SERVICE BULLETIN

CHECKING OR REPLACEMENT OF THE EXHAUST MUFFLER OF REDUCED NOISE EMISSION PART NO. 979 405

MANDATORY FOR ROTAX® ENGINE TYPE 914 F SB-914-015

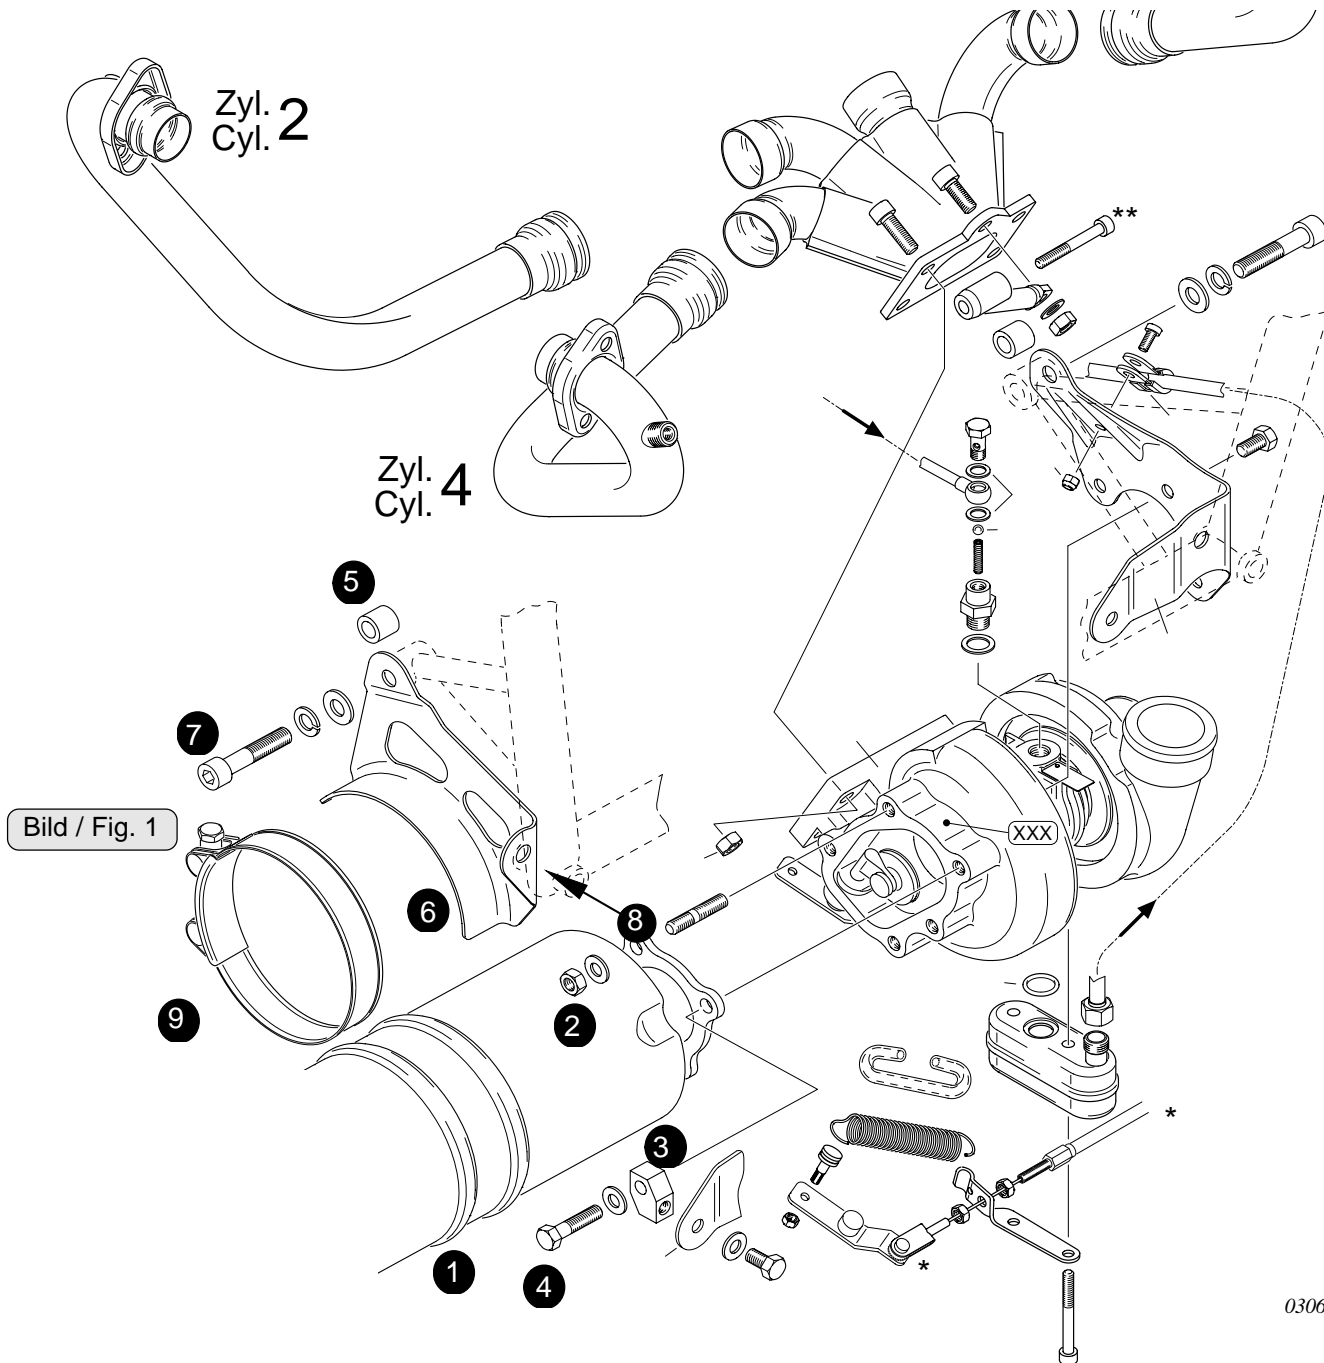
- Attach muffler (1) with washers and M8 nuts (2) on turbine housing.
- Secure the support plate (3) with washers and hex. hd. screws (4) M8x35 on turbine housing.

- Tighten muffler attachment nuts M8 (2) to 25 Nm (220 in.lb).
- Place spacer (5) 10,5/17/15 part no. 847 840 into left arm of engine suspension frame and attach muffler bracket (6) with washer and Allen screw (7) M10x50 on crankcase.
Tightening torque of the M10 screws = 35 Nm (310 in.lb).

- Re-establish attachment (8) muffler bracket - engine suspension frame (not in supply volume of engine).
Tightening torque as specified by the aircraft builder.

Bild / Fig. 2

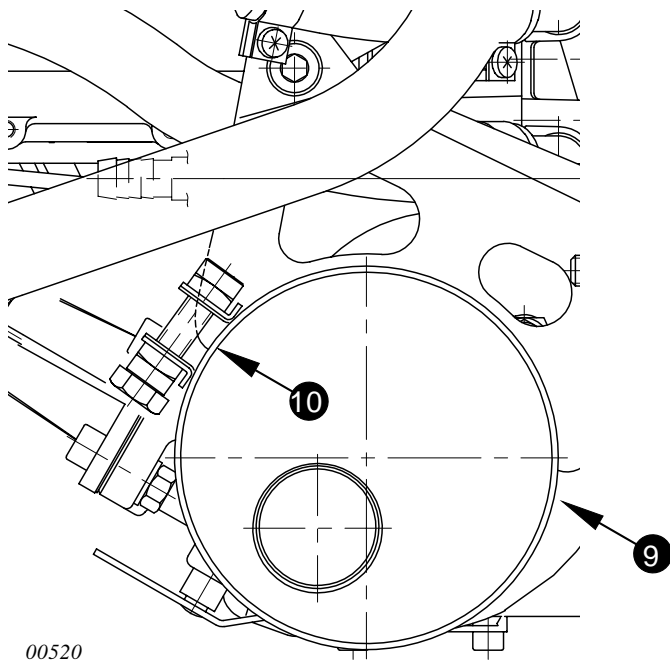
- The muffler will be attached by clamp (9).
 - **ATTENTION:** Place clamp (9) in position such that the tension free zone (10) comes to rest on edge of muffler bracket. See fig. 2.

Bild / Fig. 3

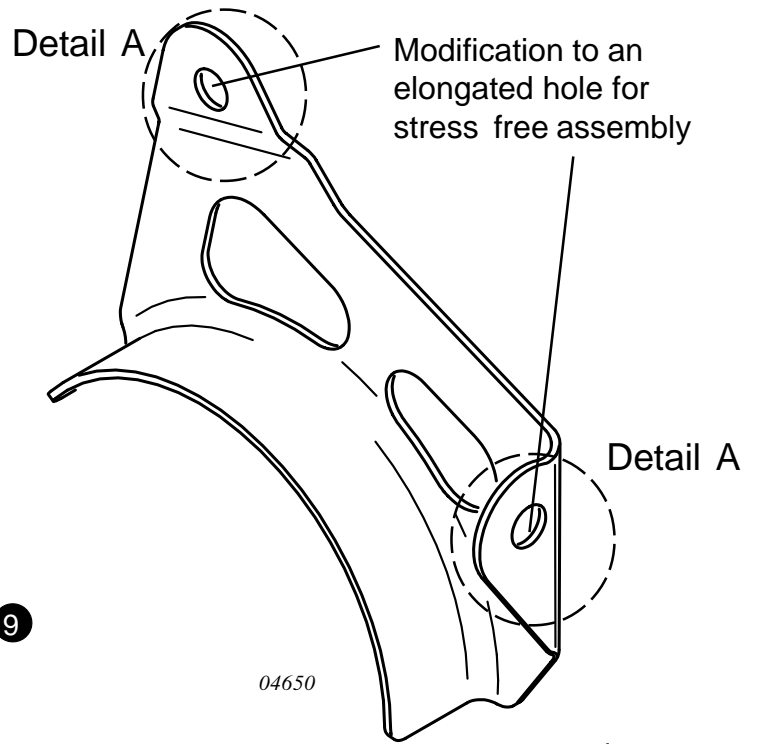
- **ATTENTION:** Doublecheck that the muffler is assembled free of stress. If an assembly free of stress is not possible rework the muffler bracket at the position of the Allen screw (7) and the attachment (8) muffler bracket - engine suspension frame into the stress free direction to get a elongated hole. Rework elongated hole with a metall-file only as required. Max. 3mm (0,12 in).

max. 3 mm (0,12 in)
in one direction only

max. 3 mm (0,12 in)
in one direction only

Bild / Fig. 4

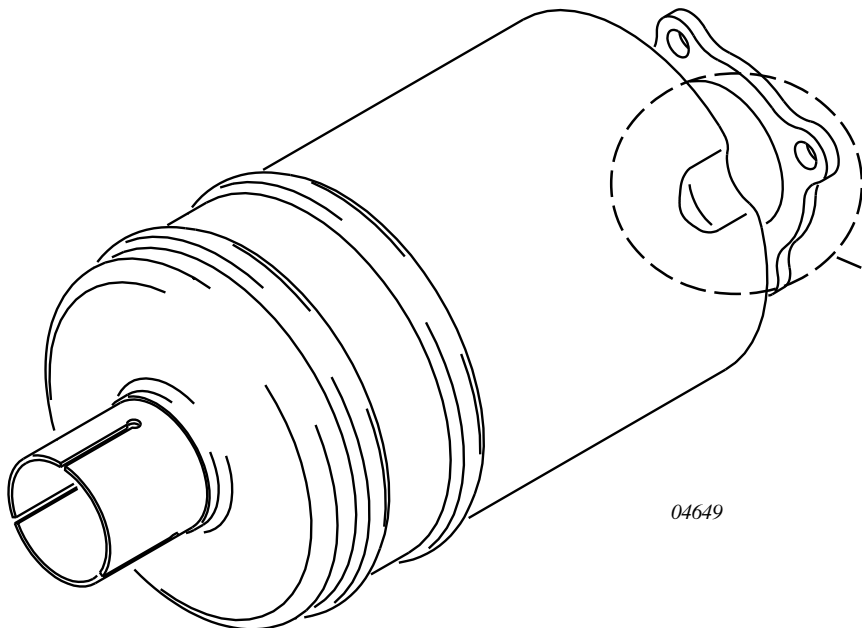
◆ **NOTE:** Particular inspection for cracks in the area as shown in fig. 4.

Inspect this area for cracks!

3.1) Inspection of the exhaust muffler:

- Visually inspect exhaust system
- Inspection of the exhaust system of existing cracks
